## PRELIMINARY SITE PLAN

## GRANDVIEW

SINGLE-FAMILY CONDOMINIUM COMMUNITY  
ROCHESTER HILLS, OAKLAND COUNTY, MICHIGAN

REVISION: Revision #6

## OVERALL DEVELOPMENT PLAN

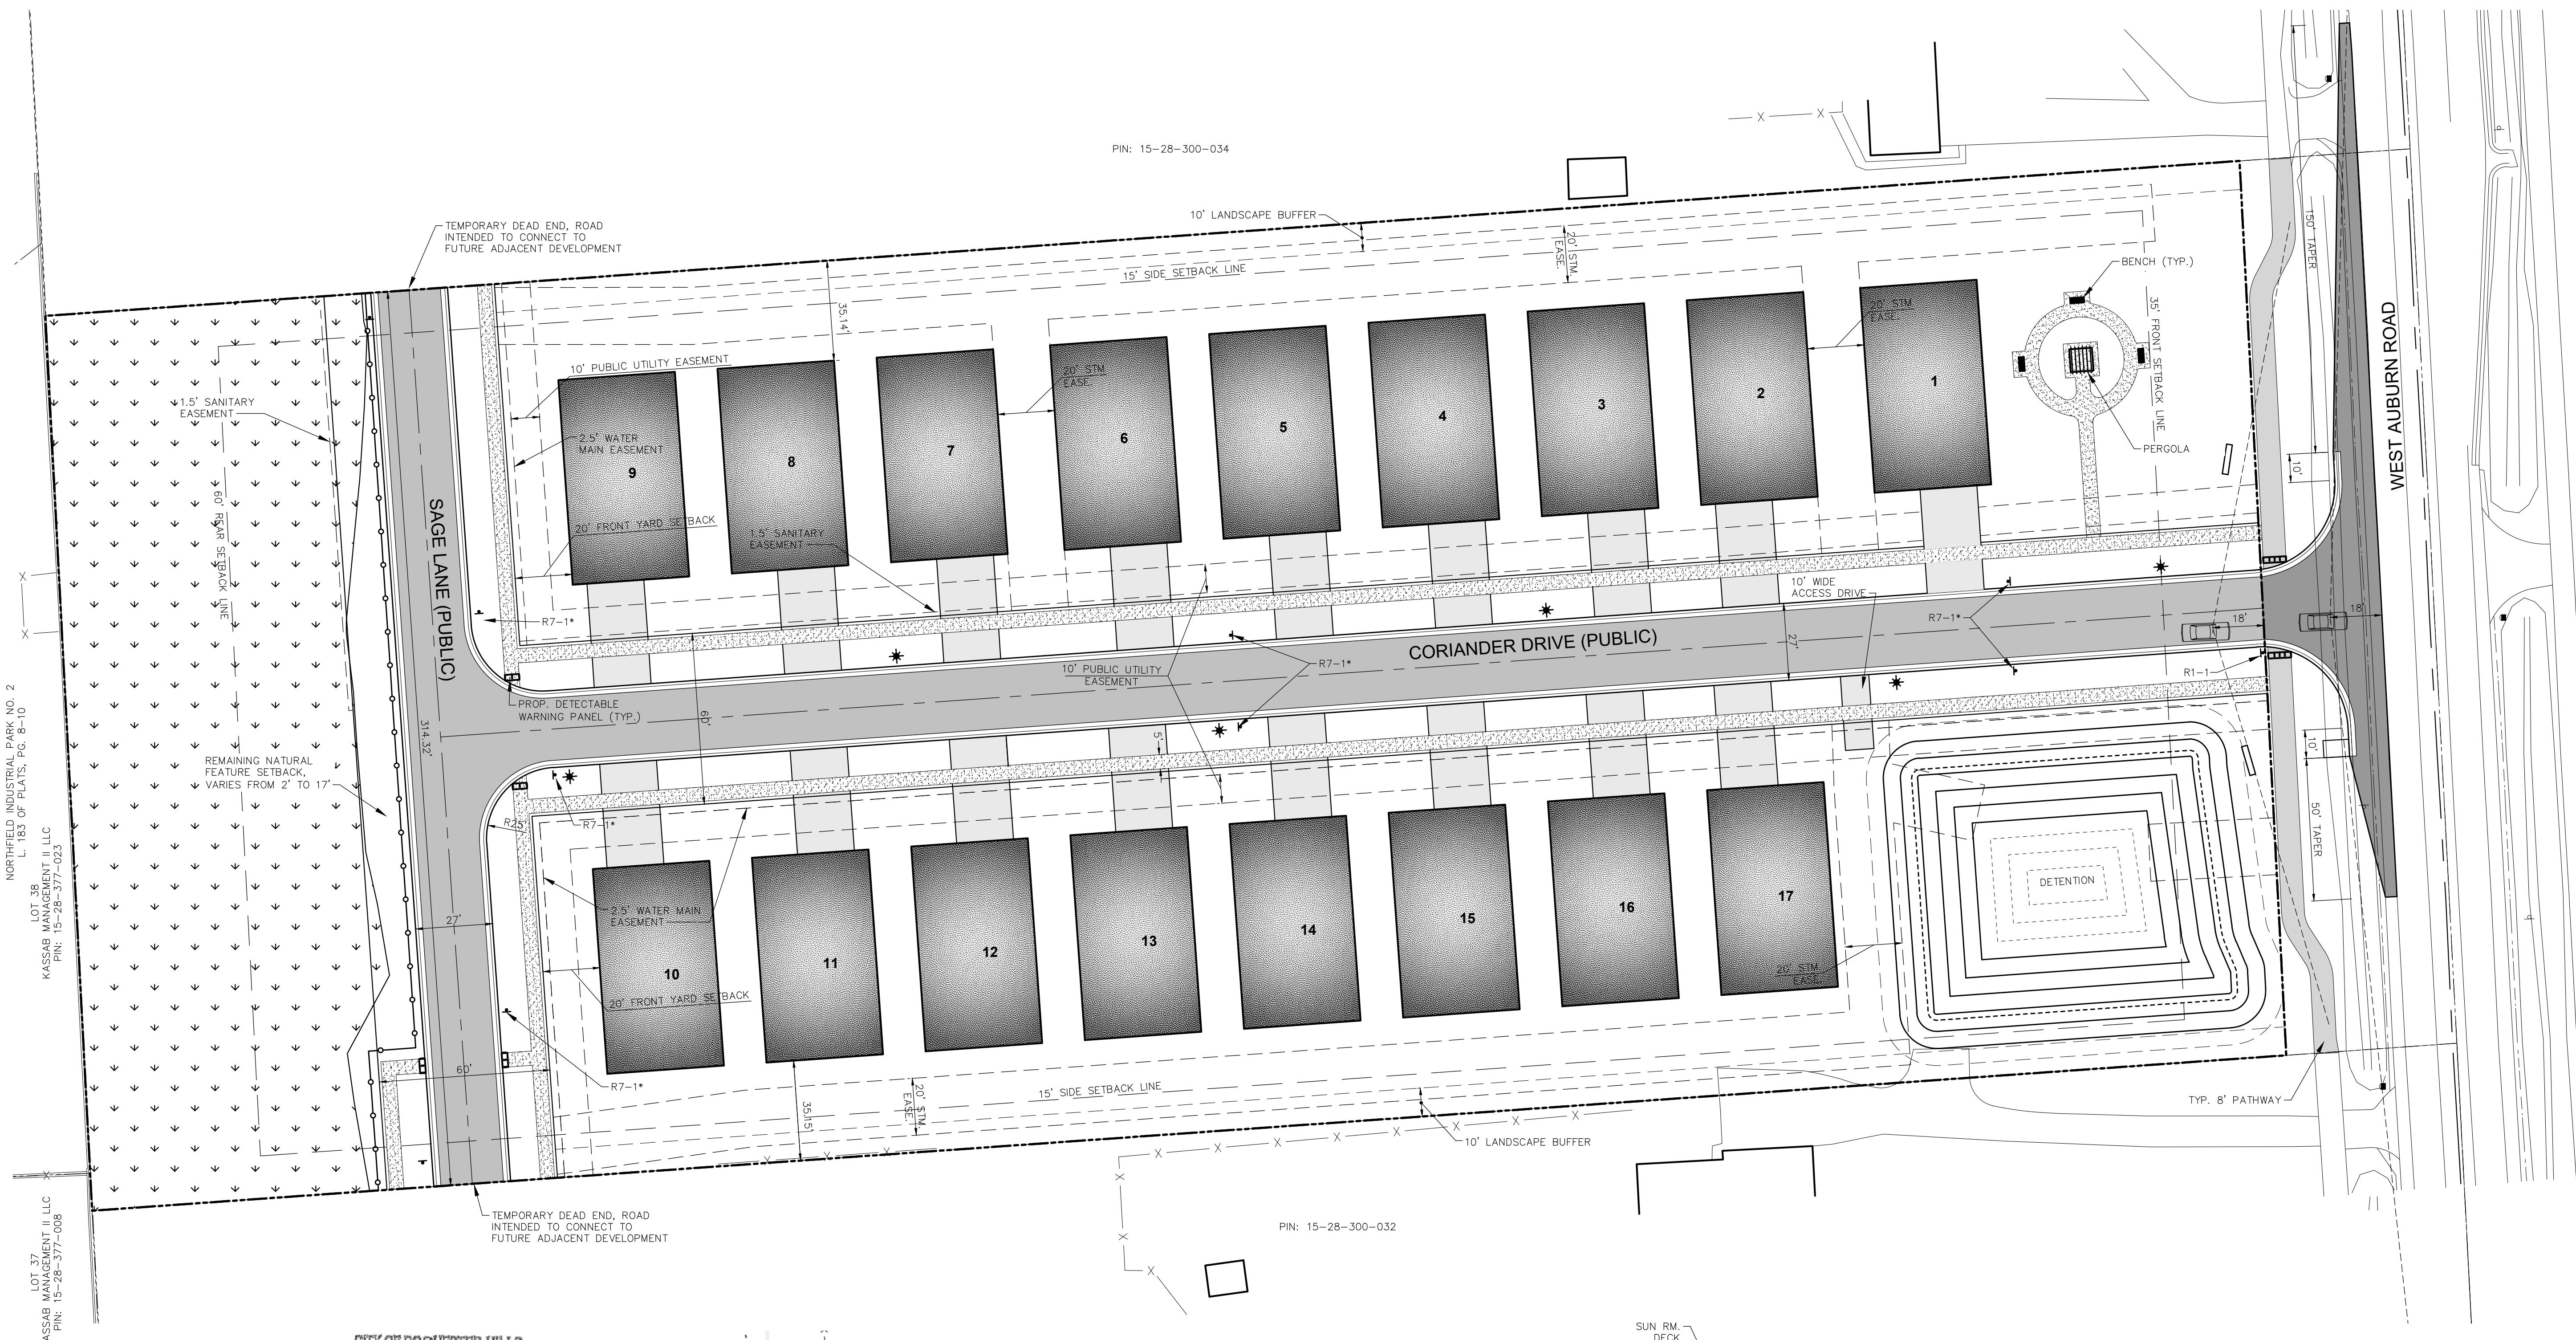
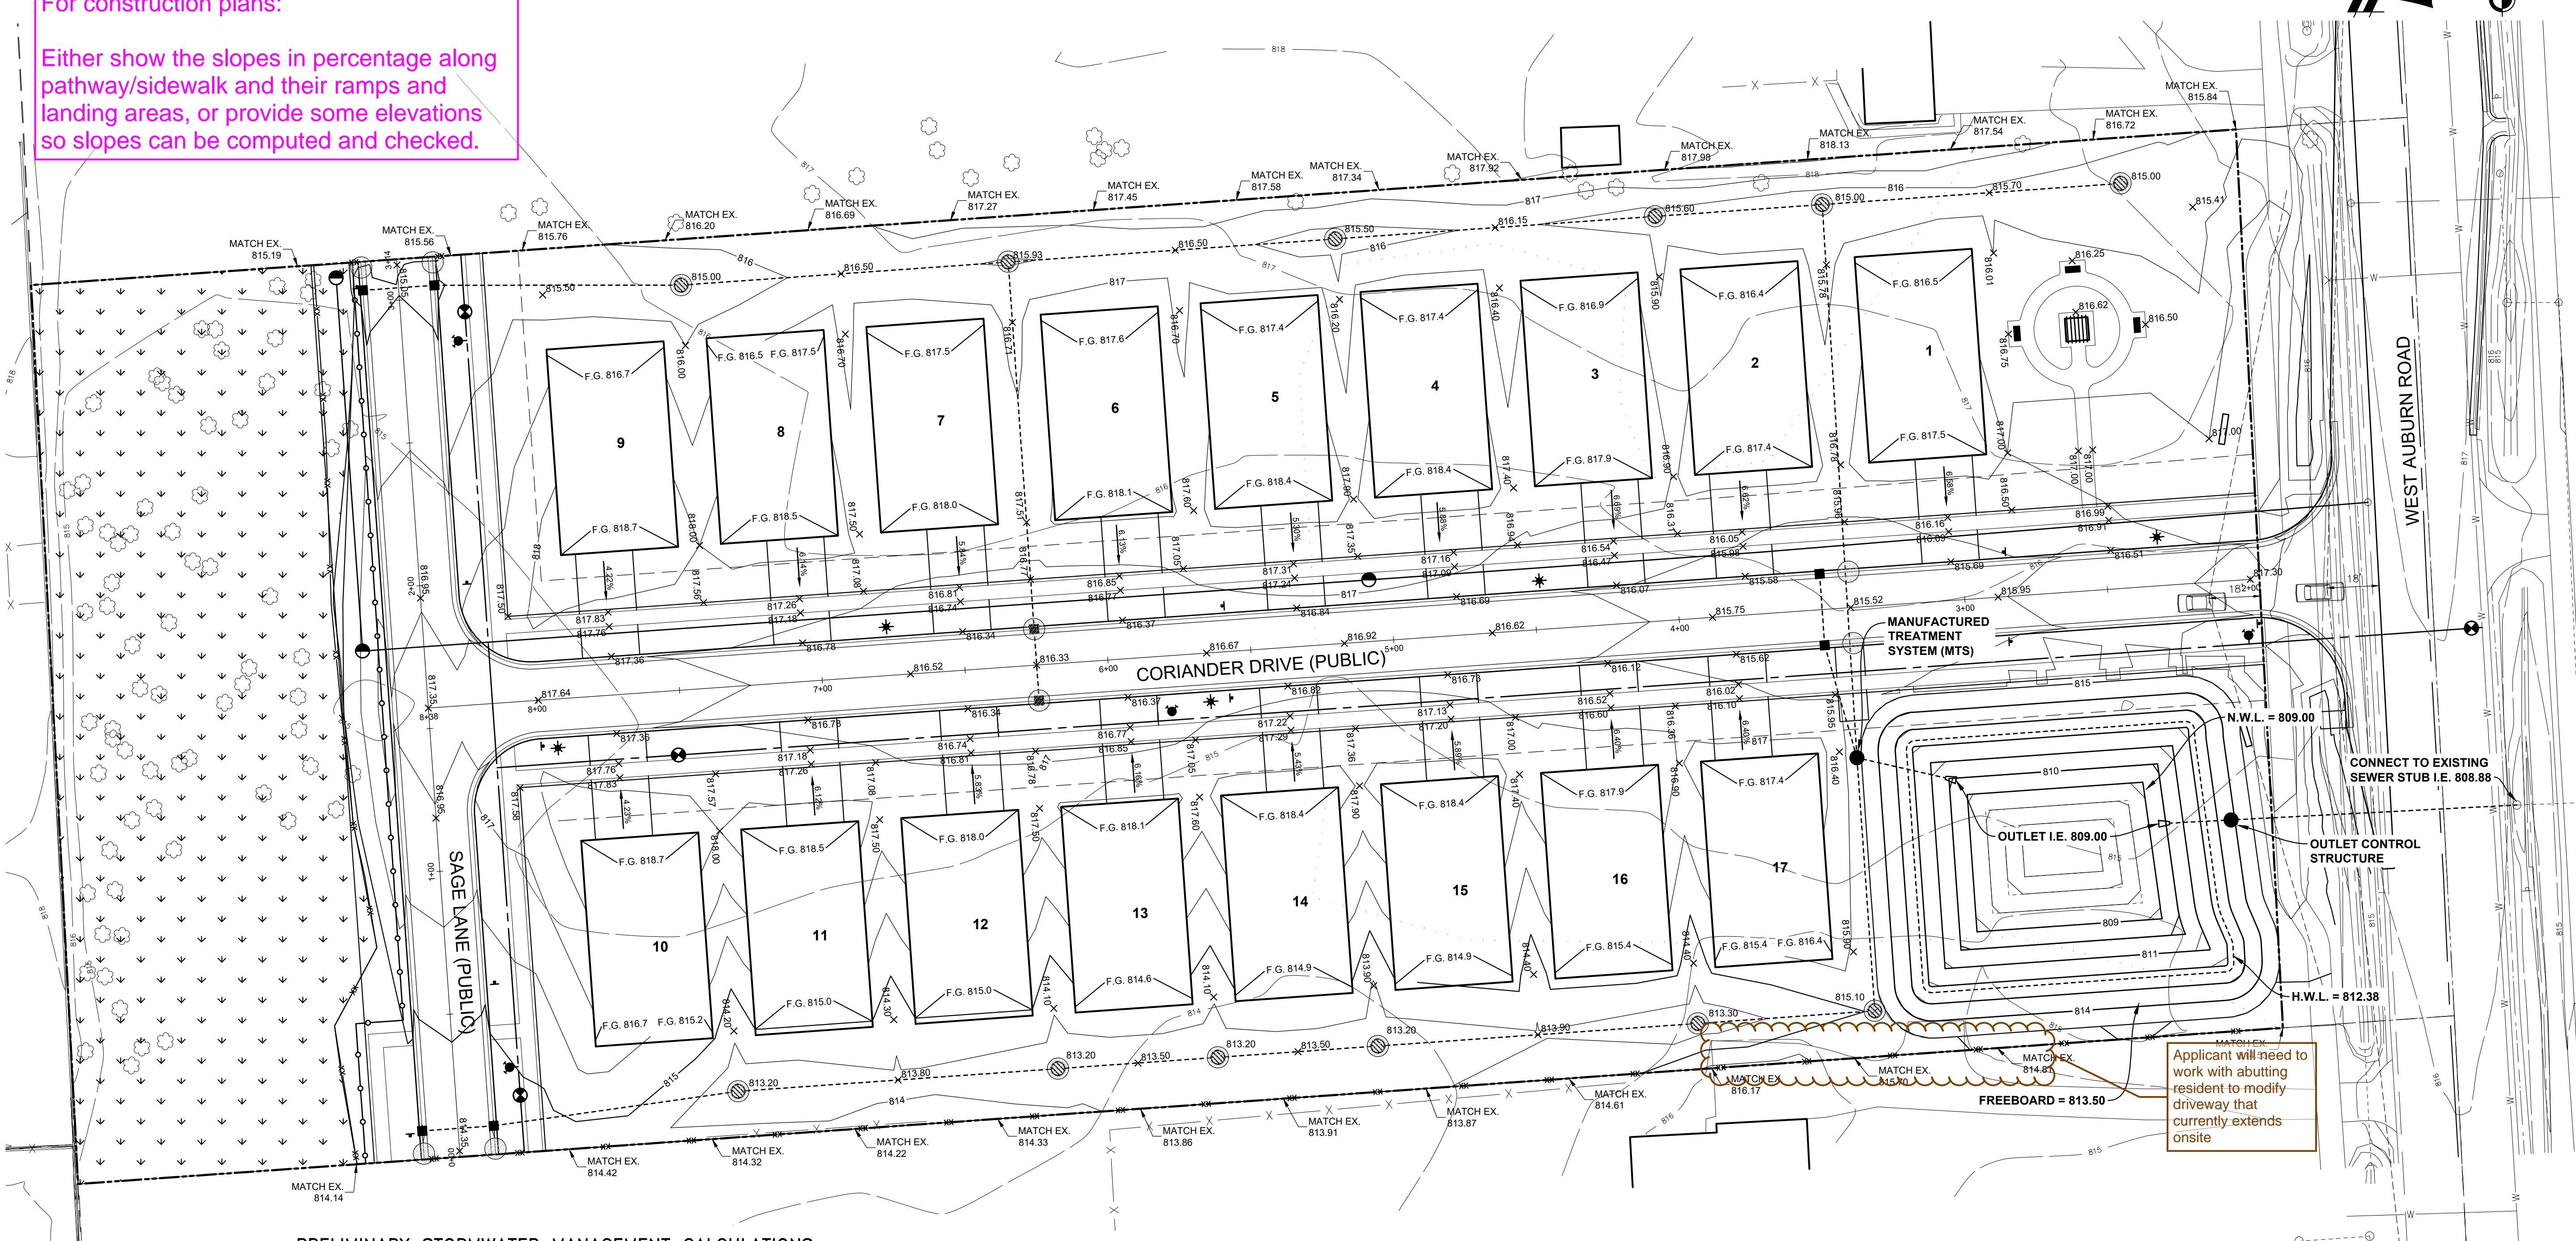
For construction plans:

Either show the slopes in percentage along pathway/sidewalk and their ramps and landing areas, or provide some elevations so slopes can be computed and checked.
